Addendum No. 1

Project Name: 46th St and Post Rd I/I Removal Project
Project Number: 2025.01995
Date: February 27, 2026

The extent of this addendum is as follows:

SHEET NO.
2 of 44

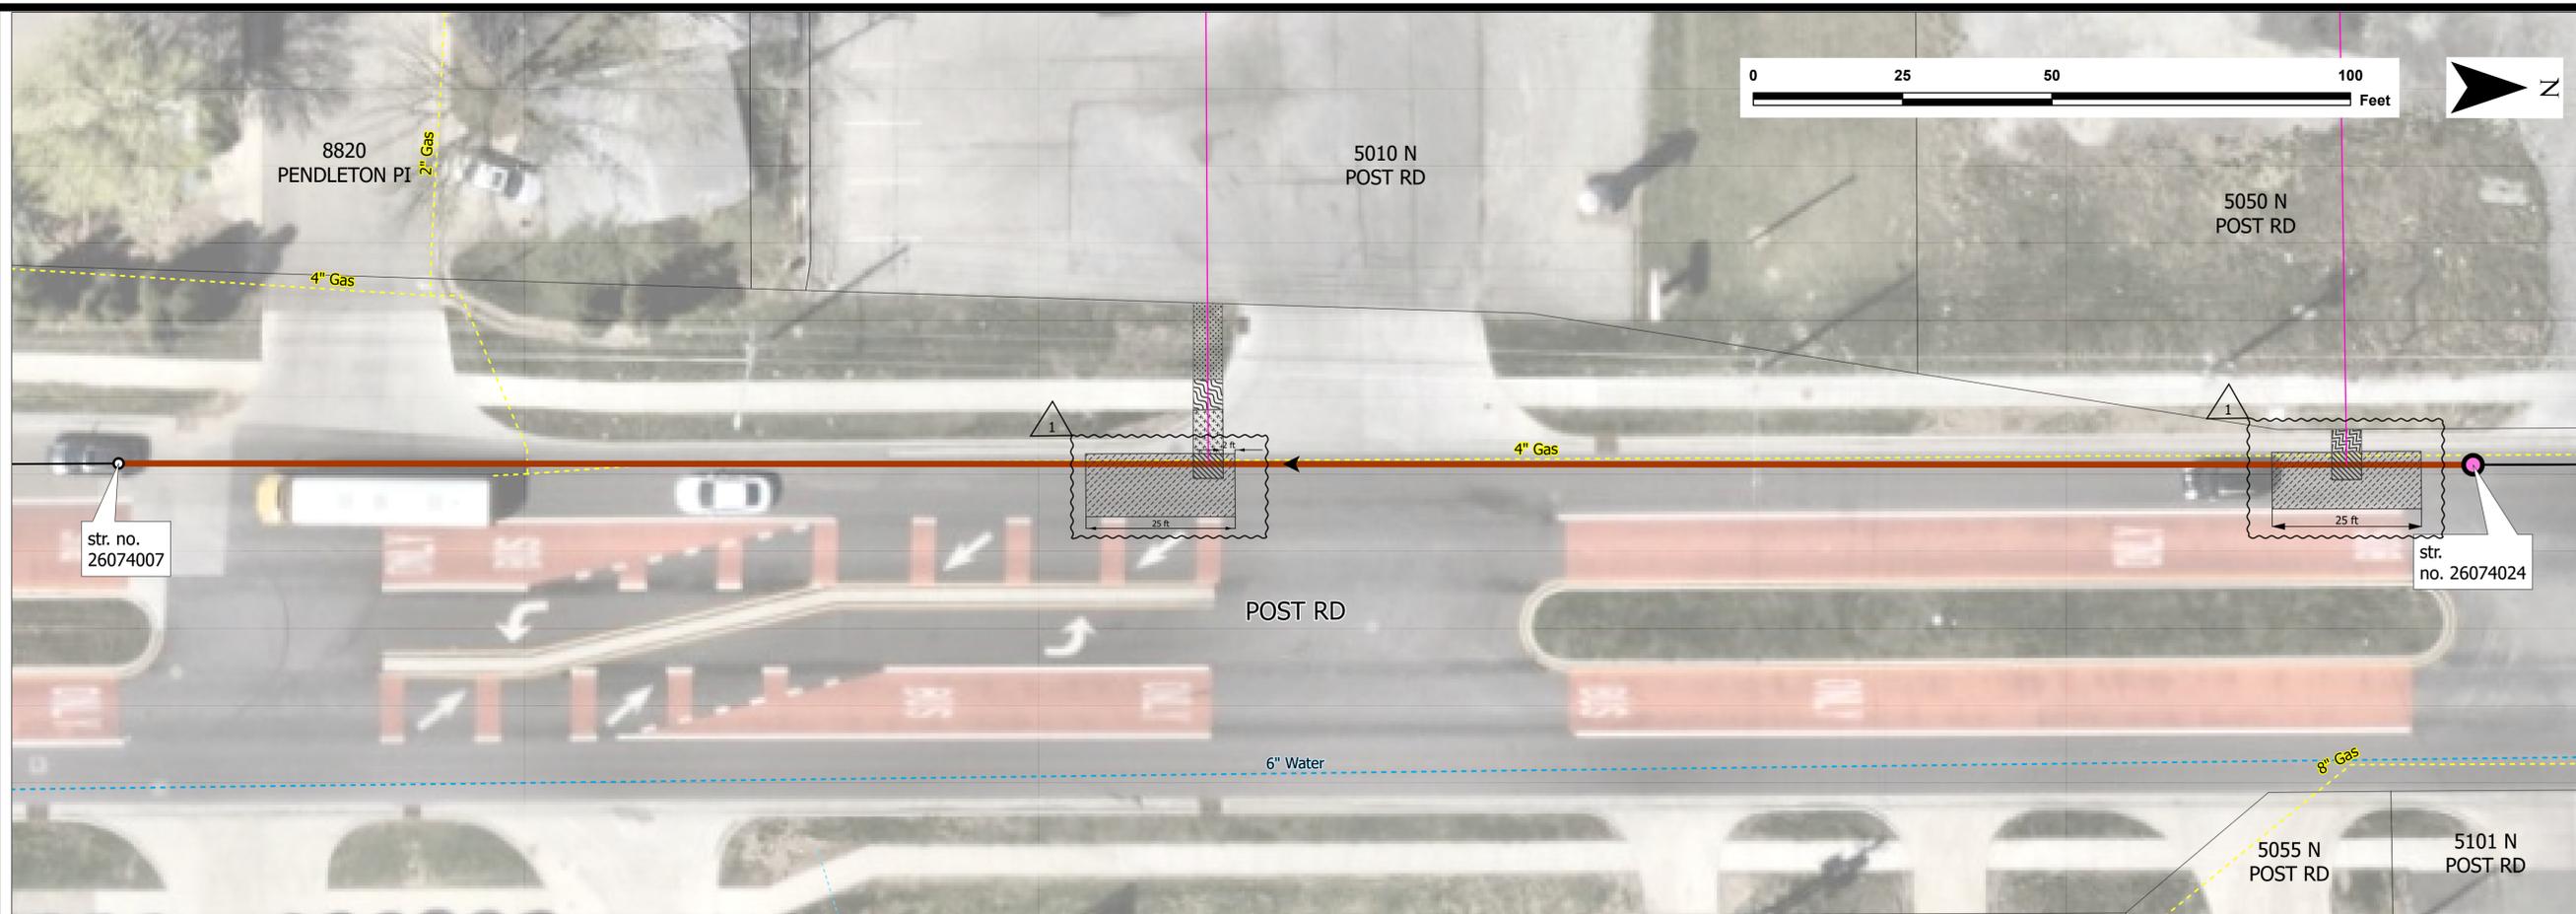
REVISIONS			
REVISION NO.	SHEET NO.	DESCRIPTION	DATE
1	2	ADDED INDYGO BUS CONTACT, UPDATED DRAWING INDEX	02/24/2026
1	23	UPDATED MILLING EXTENTS AND RESTORATION NOTES	02/24/2026
1	25-28	UPDATED RESTORATION NOTES	02/24/2026
1	42-44	UPDATED RESTORATION DETAILS	02/24/2026
